G-1906S etc.

PRODUCTION CHANGES

FIGURE 4. SCHEMATIC DIAGRAM OF AMPLIFIER

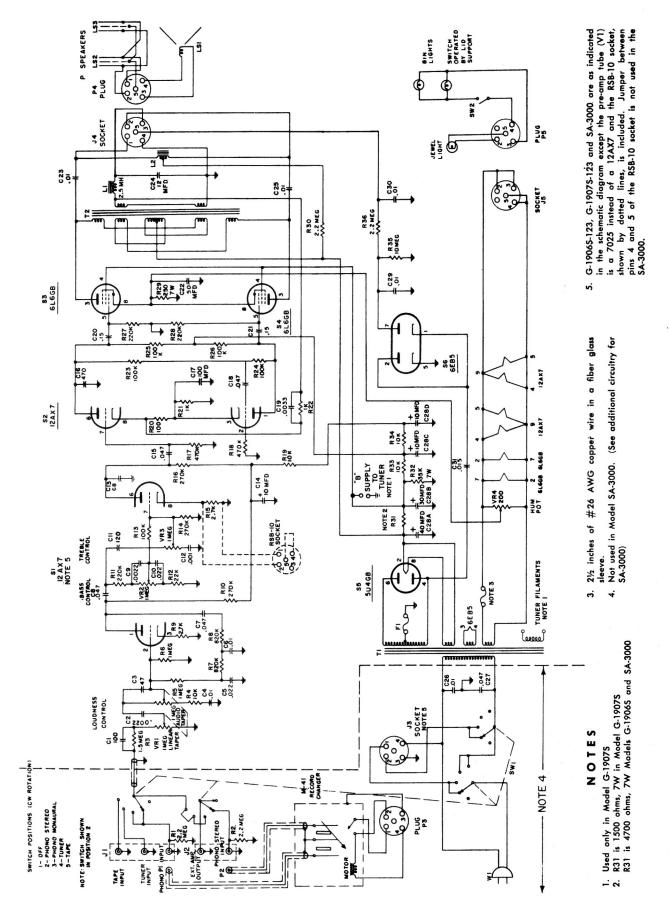
Run 54. Add 1 megohm resistor, Part No. 66-5108340, across phono input jacks.

Run 55. Removed 2.2 megohm resistor from phono input jack to improve bass response. Relocated components originally connected to pin 1 of 5U4 socket to facilitate production.

Run 56. Changed power transformer from -1 to -2 and removed the .047 mfd line by-pass capacitor C27.

In later production amplifiers, capacitor C13 was changed from 270 mmf to 68 mmf to increase the highfrequency response.

FIGURE 7. PARTS LOCATION BEFORE AND AFTER RUN 57

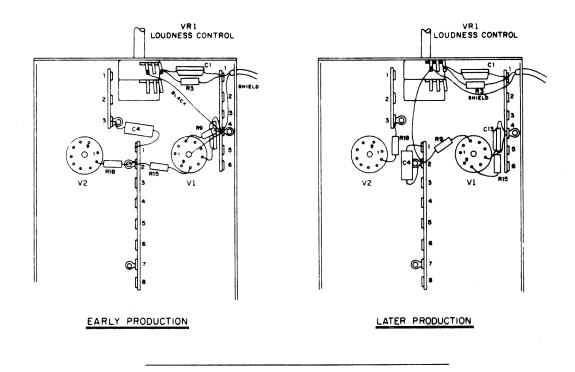
Run 57. Changed location of grounds to facilitate production and reduce residual hum. These changes, illustrated in figure 7, are as follows:

- The ground lead of the .01 capacitor C4 was changed from lug 3 of the 3-lug terminal strip to lug 2 of the 8-lug terminal strip.
- b. The ground lead of the 470 K, one-half watt, resistor R18 was changed from lug 2 of the 8-lug terminal strip to lug 3 of the 3-lug terminal strip.

- c. The ground lead of the 2.7 K, one-half watt, resistor R15 was changed from lug 2 of the 8-lug terminal strip to lug 4 on the 6-lug terminal strip.
- d. The ground lead of the 2.7 K, one-half watt, resistor R9 was changed from lug 4 on the 6-lug terminal strip to lug 2 of the 8-lug terminal strip.
- e. The outer shield of the input cable from the function switch was changed from lug 4 of the 6-lug terminal strip to the low end of the loudness control.
- f. The black wire from the low end of the loudness control was changed from lug 4 of the 6-lug terminal strip to lug 2 of the 8-lug terminal strip.
- g. After the above changes are made, adjust the hum pot for minimum.
